• **BRAKES—REAR BRAKE NOISE—"MOANING/GROANING" FROM REAR BRAKES WHEN COLD** • **NOISE—"MOANING/GROANING" FROM REAR BRAKES WHEN COLD**	**Article No. 00-26-5**

MERCURY: 1999-2001 COUGAR

Figure 1 - Article 00-26-5

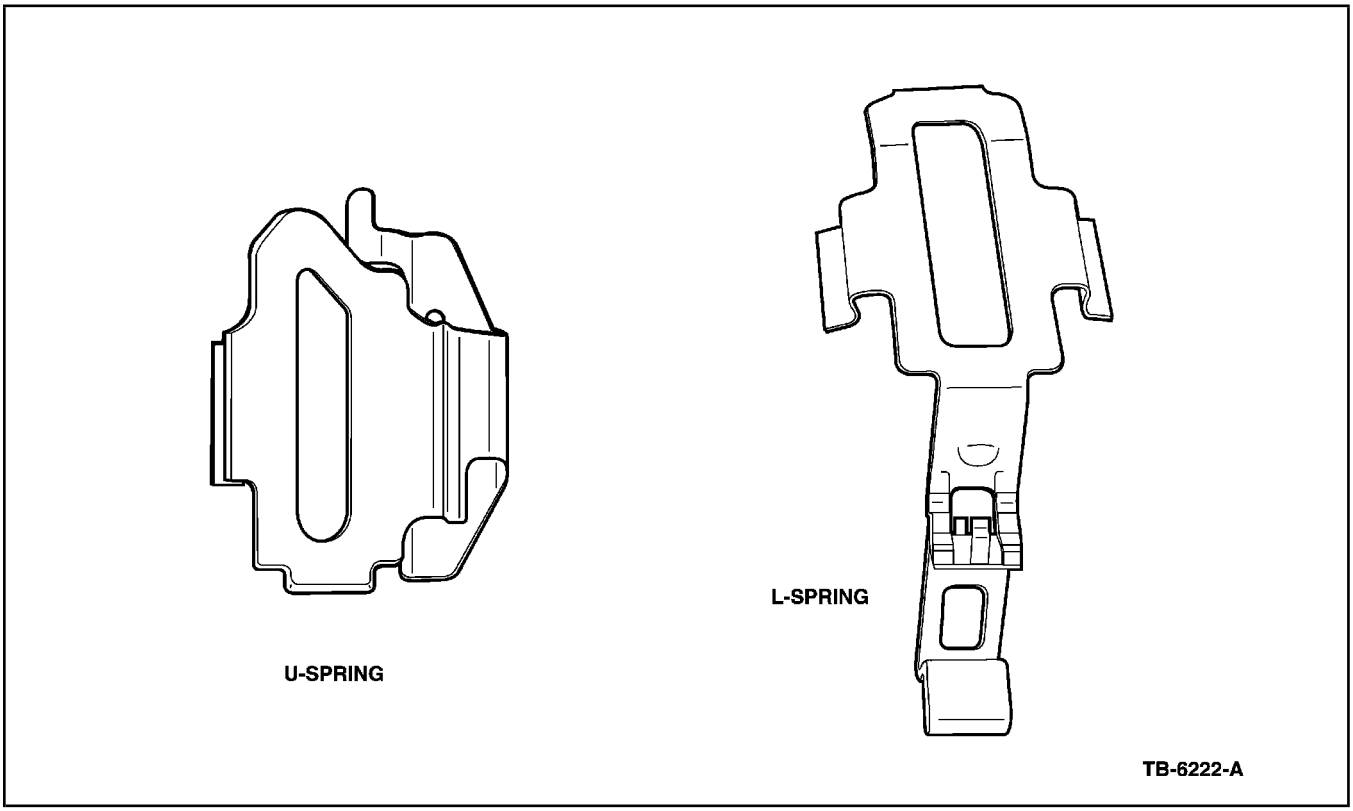
1. Lift and support vehicle. Refer to the appropriate Workshop Manual, Section 100-01.
2. Remove both rear tire assemblies.
3. Remove rear brake pads per instructions in the Workshop Manual, Section 206-04.
4. Remove U-spring from the top of the caliper and replace with L-spring supplied in kit (Figure 1).

NOTE
THE LEG OF THE L-SPRING FACES THE OUTSIDE OF VEHICLE.

Figure 2 - Article 00-26-5

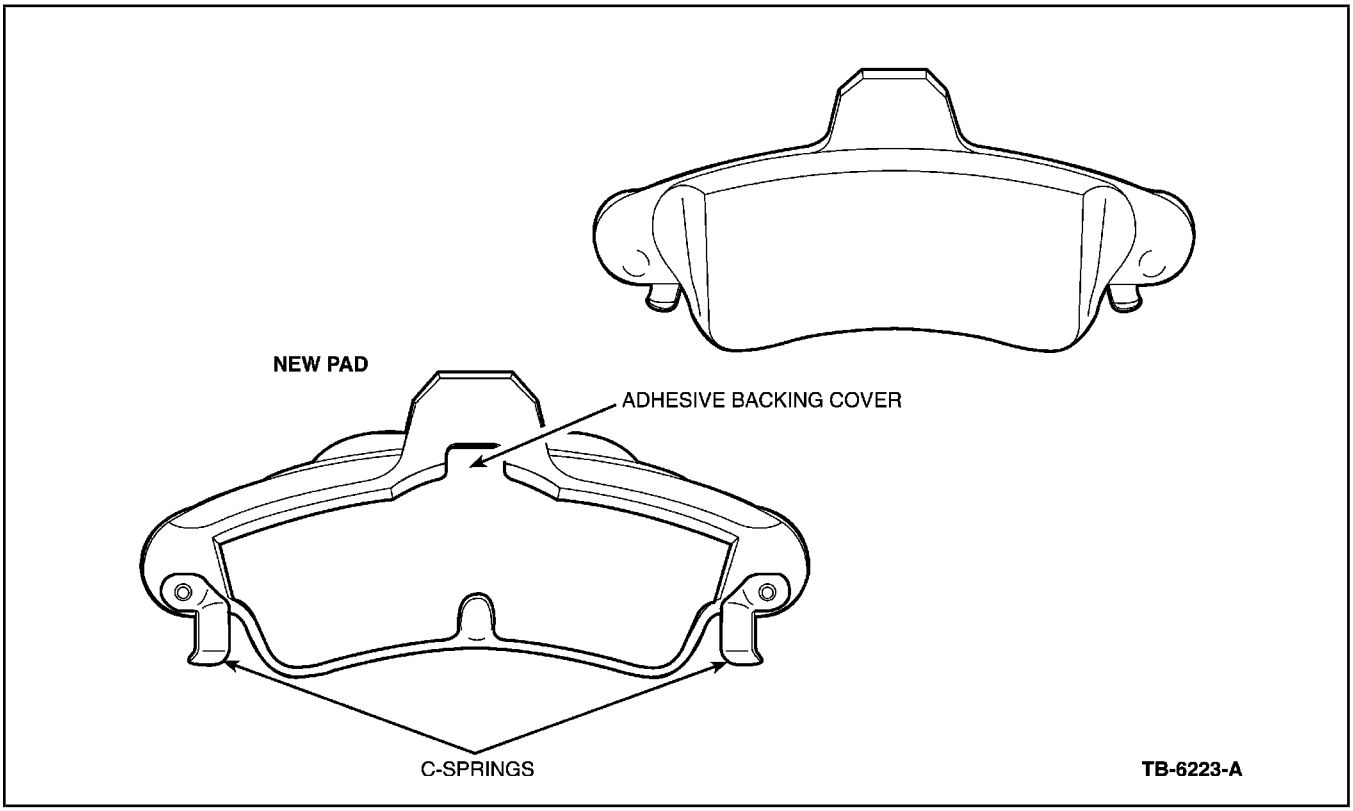
5. Remove adhesive backing protection from new pads with C-springs (Figure 2) and install new pads into caliper. Use Pads XS7Z-2200-AA for vehicles without Pad Wear Sensors (PWS) or XS7Z-2200-BA for vehicles with Pad Wear Sensors (PWS).

Figure 3 - Article 00-26-5

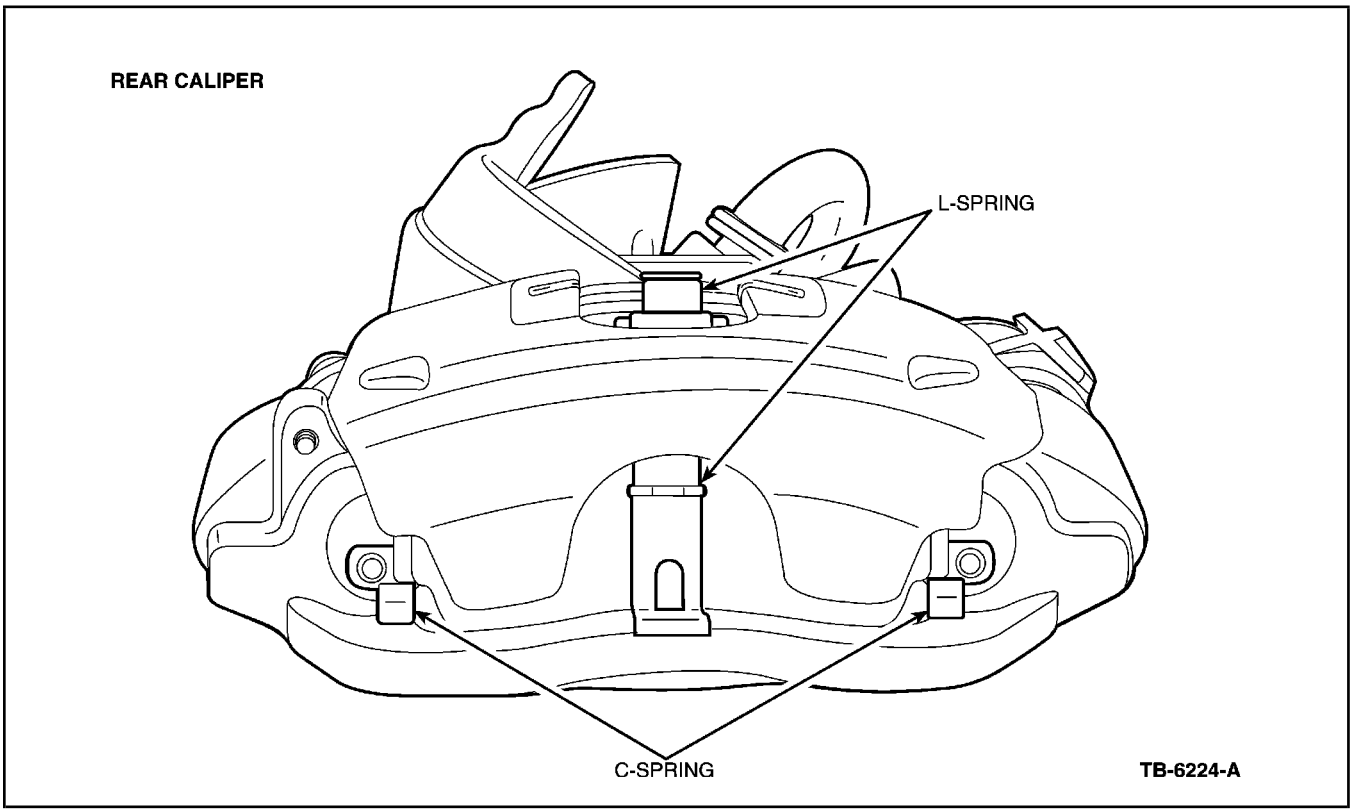
NOTE
ENSURE THAT, WHEN INSTALLED, THE C-SPRINGS SIT ON THE EDGE OF THE CALIPER (SEE FIGURE 3).
